Access Compliance Report Public Rights-of-Way (Curb Ramps)

Main Street: CURRIE_CIR Cross Street: ERVIN_LN Location: NE

ADA ID: RPAT211005140339 Ramp Type: Type 1 - Perpendicular Diagonal Initial Pass/Fail: Fail Overall Compliance: No Severity Score: 4

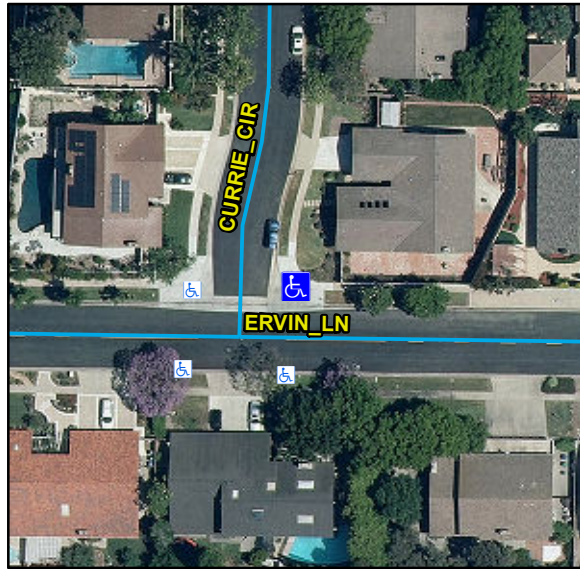
Compliance	Description	Data	Compliance	Description	Data
N/A	Ramp Length (in)	72	N/A	Flare Type LT	
No	Ramp Width (in)	47			N/A
Yes	Ramp Run Slope (%)	7.3	N/A	Flare Slope LT (%)	N/A
Yes	Ramp Cross Slope (%)	0.5	N/A	Flare Traversable LT	N/A
N/A	Landing Present	N/A	N/A	Flare Type RT	
N/A	Landing Length (in)	N/A			N/A
N/A	Landing Width (in)	N/A	N/A	Flare Slope RT (%)	N/A
N/A	Landing Run Slope (%)	N/A	N/A	Flare Traversable RT	N/A
N/A	Landing Cross Slope (%)	N/A	N/A	DWS Provided	N/A
N/A	Landing Movement Obstructed?	N/A	N/A	DWS Contrast	N/A
	Landing Movement Type	N/A	N/A	DWS Length (in)	N/A
N/A	Landing Shared	N/A	N/A	DWS Full Width	N/A
N/A	Clear Space	Yes	N/A	DWS Offset Left (in)	N/A
N/A	Clear Space To Crosswalk (in)	N/A	N/A	DWS Offset Right (in)	N/A
N/A	Marked Crosswalk 1	No	N/A	Marked Crosswalk 2	No
	Crossing 1 Direction	W		Crossing 2 Direction	S
	Marked Crosswalk 1 Width (in)	N/A		Marked Crosswalk 2 Width (in)	N/A

Remove & Replace Curb Ramp With Two New Directional Ramps or Equivalent.
